SERVICE BULLETIN: JSB031

Issue: 3

Subject: Engine Through Bolt Replacement and Upgrade

Affected Models: Jabiru 2200 & 3300 Engines in FLIGHT TRAINING

Figure 1 – General Engine Layout

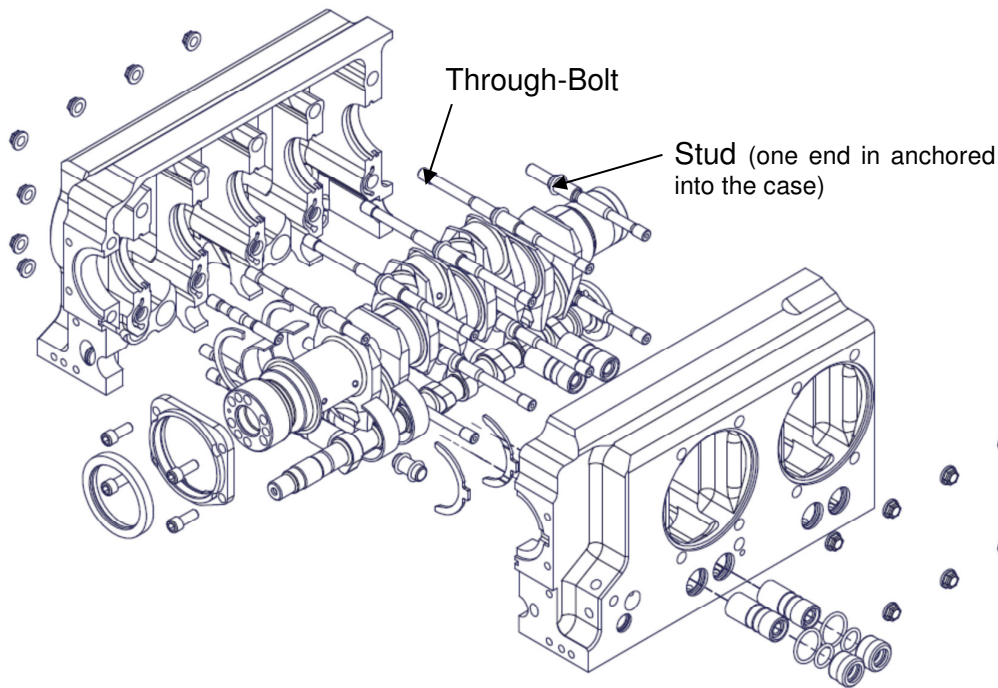
- Jabiru Engines are assembled using a combination of Through-Bolts and Studs – as shown in Figure 1 below. The number of through-bolts varies depending on which engine model is considered but there are always 6 studs (not all with the same part number). The through-bolts and studs hold the cylinders in place and the halves of the crankcases together.

Figure 2: Bolt torques.

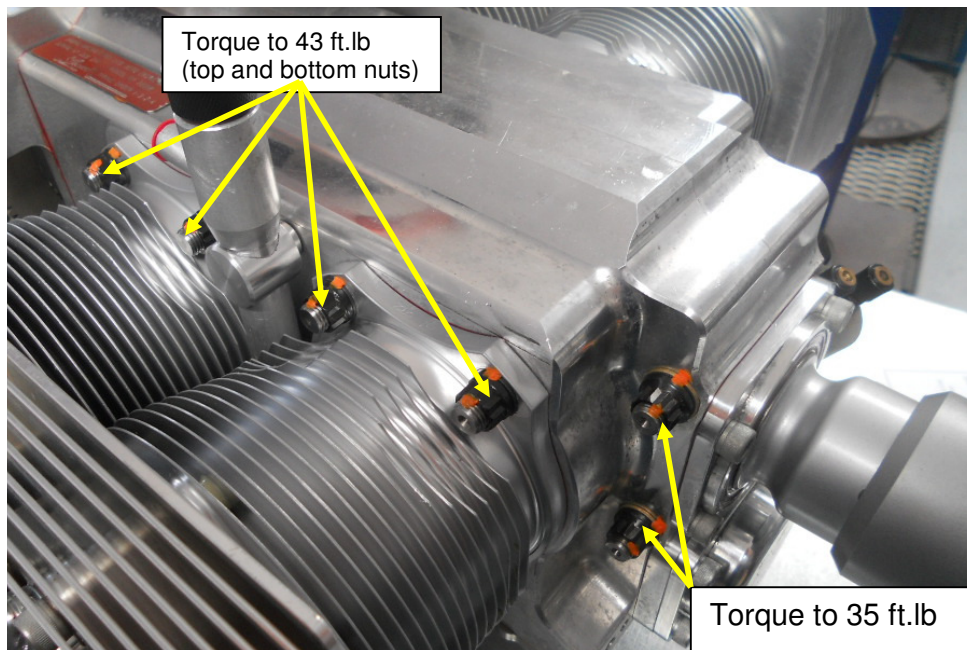
At the next 25hrly service, check the torque setting of 12 point nuts with a calibrated torque wrench. Prior to checking the torque, conduct crankshaft friction test as per section 6.2. If the torque was found to be less than 43 ft/lbs they should be retorqued to 43 ft lbs, if they are less than 43 ft lb. Reapply torque seal. Please see Figure 2.

Only loosen and change the nuts/washers on one bolt at a time. Then torque to 43 ft lb before undoing the next bolt. This will avoid losing too much clamping force of the case. If a locking compound was used on the bolt/nuts, threads must be cleaned before nuts are refitted. Once all bolts are done check the torques and apply torque seal. Please see Figure 2.

Figure 3: Coil position.

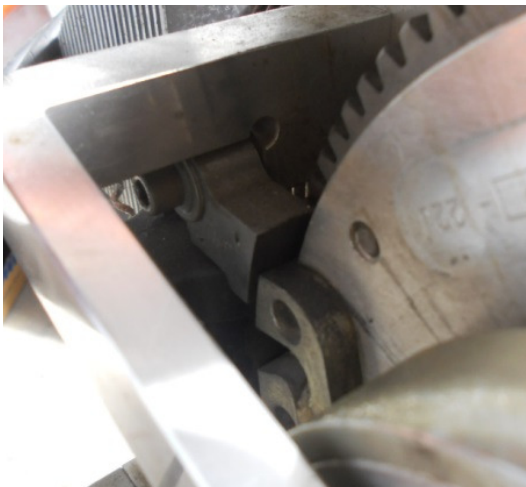
- Perform a crankshaft friction test before through bolt engine work commences. This can be done by measuring the force required to turn the propeller with a spring scale. Remove one spark plug from each cylinder. Turn the engine over several times. Position the crankshaft so that the magnets are almost lined up with the ignition coils, see Figure 3. Then using a spring balance at the tip of the propeller blade, (take care not to damage the propeller blade) pull the prop slowly in the direction of rotation. Take note of the reading on the scale as you do this. You will only get about 150mm of movement before the camshaft causes the prop to move more easily.
